## SERVICE LETTER

Service Letter Number	Simplex Model	Issue Date	Revision	Revision Date
SL2010-006	R44III (244)	June 25, 2010	I/R	June 25, 2010

**Approved By:**  
Tim Pyle  
Sustaining Engineering and QA Manager**Subject:** Spray system engine wiring harness modification**Applicability:** This service letter is applicable to Simplex Manufacturing Model R44III spray systems serial numbers 244/0001 thru 244/0007.**Summary:** During test operations it was discovered that the spray system wiring harness was incorrect and when installed on the aircraft the engine would not run because the engine stop switch was mistakenly grounded to aircraft ground. This **does not** create a safety of flight issue but did cause a functionality issue.**Purpose:** This service letter provides instruction to make a wiring modification to the spray system wiring harness to allow for proper operation of the spray system engine.**Compliance:** Required for proper spray system engine operation**Weight and Balance:**

**Figure 1**

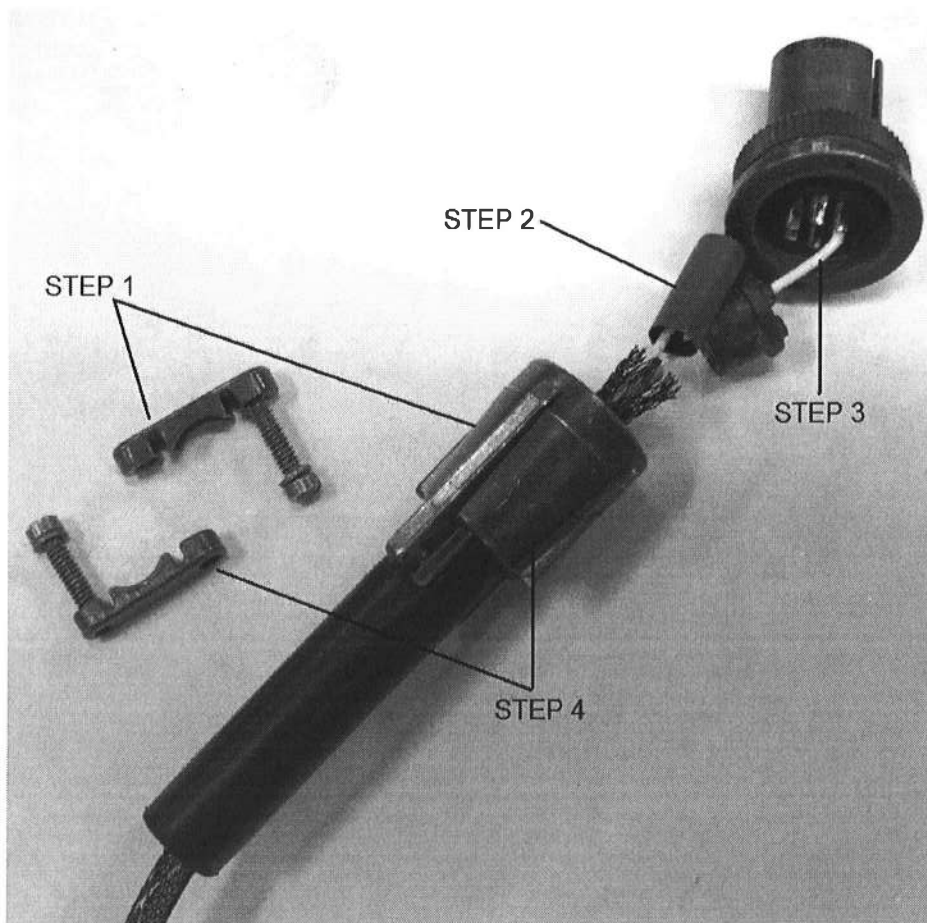
1. Remove back shell clamps and slide back shell and strain relief away from connector (Figure 1)
2. Terminate wire number SS105C20. Cover terminated wire using heat shrink tubing (Figure 1)
3. Un-solder wire number SS119B20 from connection terminal 'B' and re-solder into terminal 'A' (Figure 1). Reference Figure 2 for wiring schematic pre and post modification.
4. Re-connect back shell and clamps(Figure 1)
5. Modification is complete.
